Our Ref: 16083-LE250520
Contact: Matt Cooper

**RE: SECTION 75W MODIFICATION – MP06_0143_MOD4
THE GLADES ESTATE, MOONEE BEACH**

Appendix A – Response to DPE Matters

Title
**BULK EARTHWORKS AND NOISE ATTENUATION PLAN
GLADES ESTATE MOONEE BEACH**

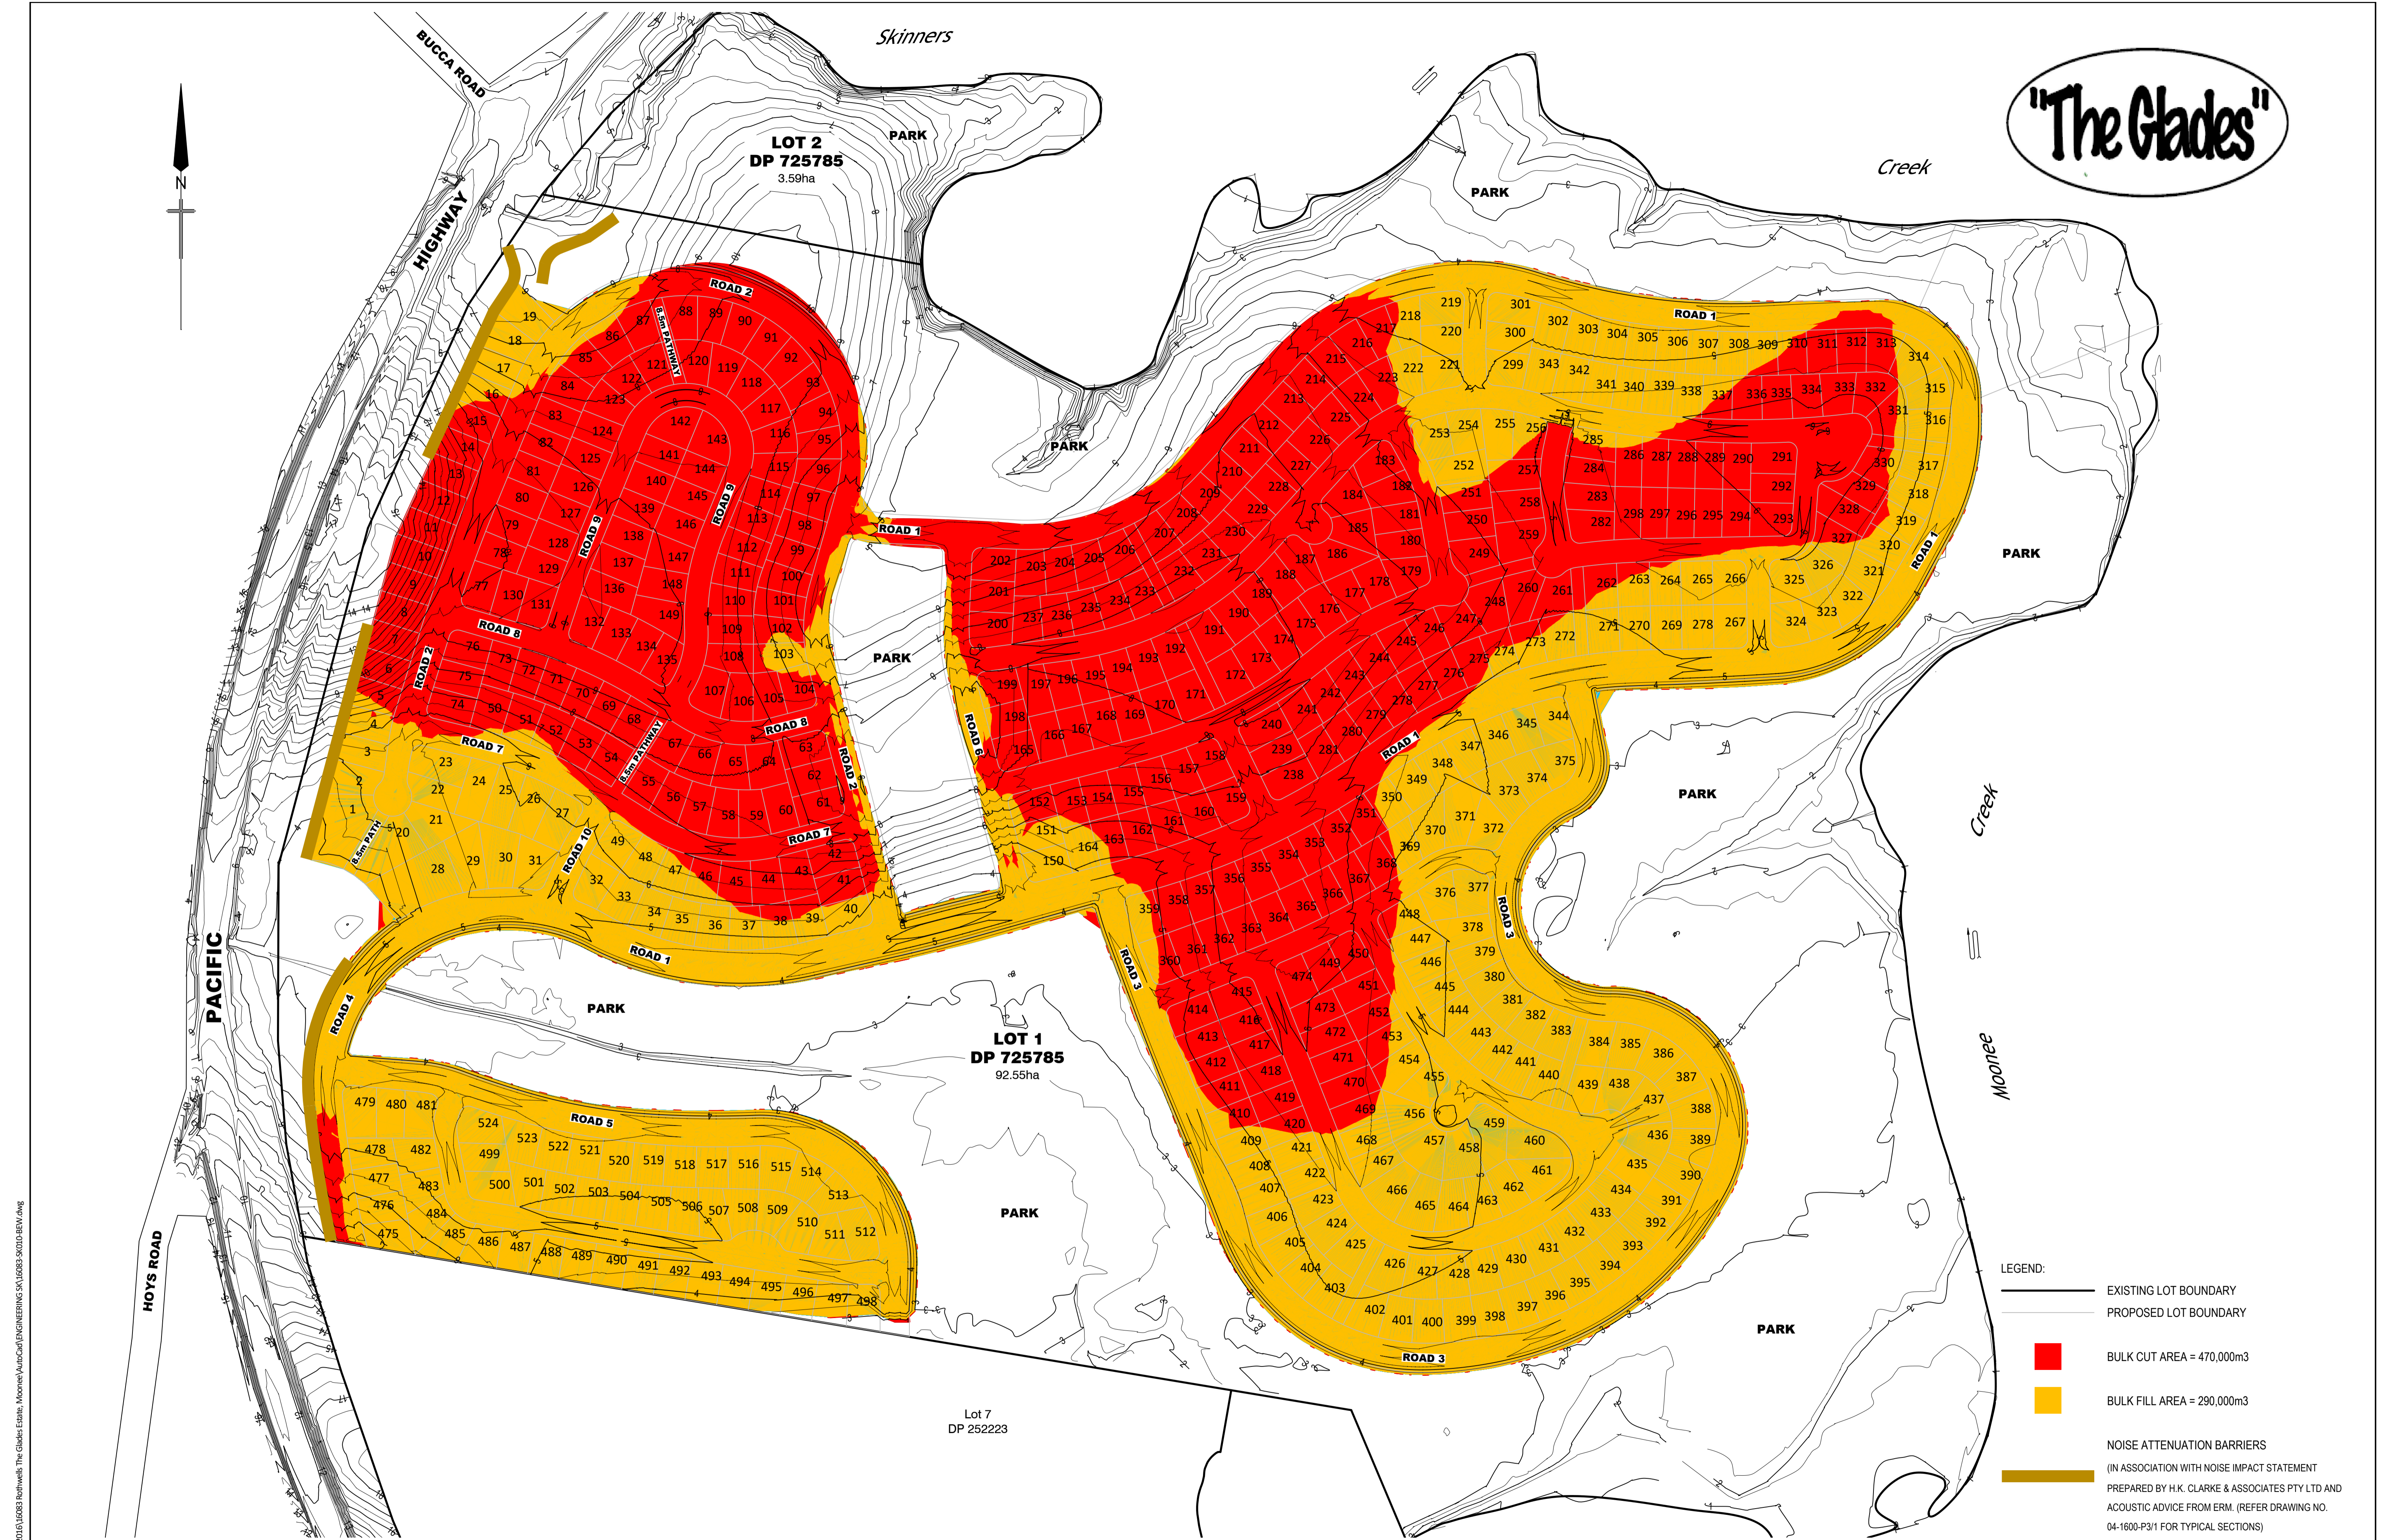
<p><u>Noise Attenuation</u></p> <p>The Department considers the proposed removal of the acoustic barrier has not been adequately justified. Additional information is required to:</p> <ul style="list-style-type: none"> • explain how the road levels of the Pacific Highway would impact on the effectiveness of and need for the acoustic barrier • demonstrate how future dwellings would achieve appropriate level of internal and external acoustic amenity • analyse other similar subdivisions in the area and detail how acoustic impacts have been addressed. 	<p><i>The proposed modification (Mod 4) has withdrawn from removal of the noise barriers (acoustic wall). The noise attenuation barriers, as originally approved have been included on the proposed Bulk Earthworks & Noise Attenuation Plan, drawing 16083-SK015.</i></p>

<p><u>Removal of Acoustic Wall</u></p> <ul style="list-style-type: none"> • Council does not support the removal of the acoustic wall unless it can be demonstrated that appropriate LAeq levels within future dwellings (as stipulated in S102(3) of State Environmental Planning Policy (Infrastructure) 2007) will not be exceeded within a typical residential dwelling. • In Council's view it would be inappropriate to defer the impost of noise mitigation onto future residential allotment owners if, to achieve acceptable LAeq levels within the dwelling, would require significant or substantial noise mitigation measures within the dwelling itself. 	<p><i>The proposed modification (Mod 4) has withdrawn from seeking the removal of the noise barriers (acoustic wall). The noise attenuation barriers, as originally approved have been included on the proposed Bulk Earthworks & Noise Attenuation Plan, Drawing 16083-SK015 dated 13/05/2020.</i></p> <p><i>Noted.</i></p>

This condition has been amended to recognise RDM's proposed updated Bulk Earthworks and Noise Attenuation Barriers Plan dated the 13/05/2020. Accordingly, it is proposed that Drawing Reference 'P3' be deleted from the table of drawings prepared by Auspacific Engineers and a new table inserted as shown below.

Project and Engineering Drawings prepared by Resource Design & Management Pty Ltd			
Drawing No.	Revision	Name of Plan	Date
16083-SK015		Bulk Earthworks and Noise Attenuation Barriers	13/05/2020

DRAWING TITLE
1% AEP CATCHMENT + 5% AEP OCEAN + CLIMATE CHANGE
PROPOSED CONDITION
WATER LEVEL (mAHD) & WATER DEPTH (m)

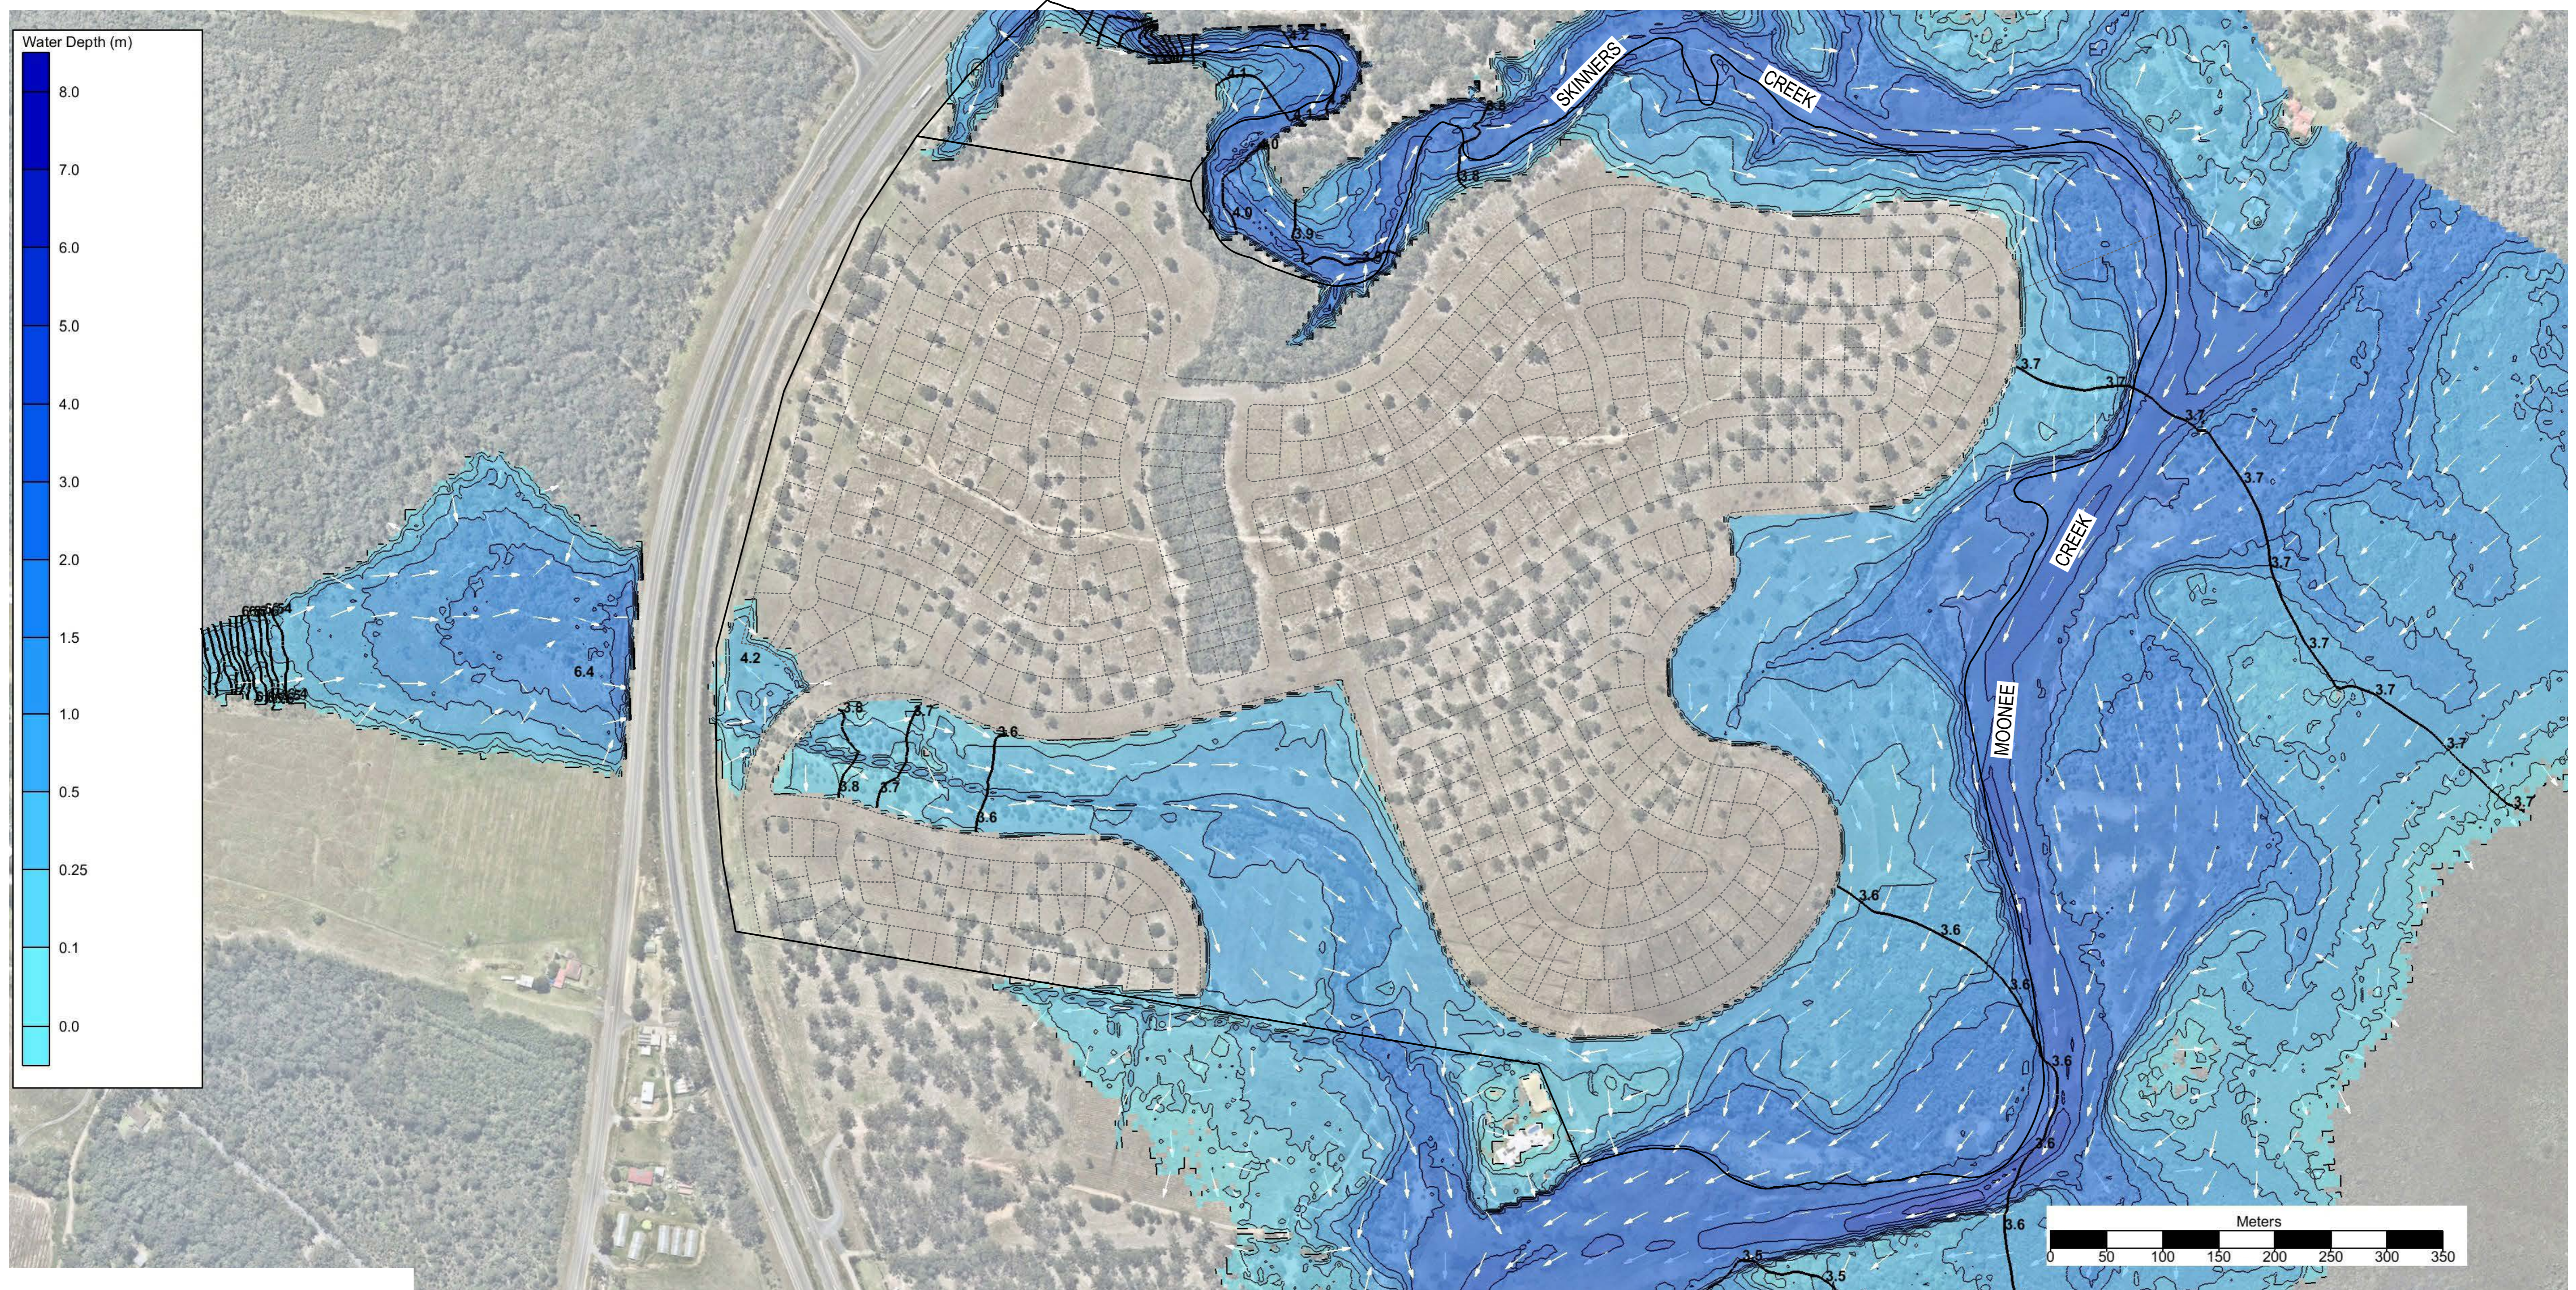
<p><u>Flooding</u></p> <p>The results of the flood modelling assessment prepared by Martens Consulting 2018 appears to be consistent with previous modelling. However, Council has some concerns with respect to the Revised Draft Conditions in the Section 75W report.</p> <p>Council recommends the following in relation to flooding:</p>	<p><i>The requirement for all residential lots to be finished at or above the scenario 5 extents (1% AEP Catchment + 5%</i></p>

3. For flooding matters the proposed revised draft condition D6 Filling of the Site be amended as follows:
- D6.1 All parts of residential lots suitable for dwellings and all residential roads are to be located above the '1% AEP Catchment + 5% AEP ocean + climate change' flood level in accordance with drawing PS01-K210 as per the Flood Assessment: The Glades Development, Lot 1 and 2 DP725785, Pacific Highway, Moonee Beach, NSW, Martens Consulting, January 2018. This is scenario five (5) in the flood assessment with a predicted flood level varying between 3.5 - 4.2m AHD for the site.

1(a) *All parts of residential lots suitable for dwellings must be finished to be above the scenario 5 extents (1% AEP Catchment + 5% AEP Ocean + climate change flood levels) plus 500mm freeboard (between 4.03 and 4.68m AHD).*

1(b) *All residential roads must be finished to be above the scenario 5 extents (1% AEP Catchment + 5% AEP Ocean + climate change flood levels)*

Note: Reference to the "scenario 5 extents (1% AEP Catchment + 5% AEP ocean + climate change flood levels) is made in accordance with drawing PS01-K210 (REV.B) as per the Flood Assessment: The Glades Development, Lot 1 and 2 DP725785, Pacific Highway, Moonee Beach, NSW, prepared by Martens Consulting Engineers.
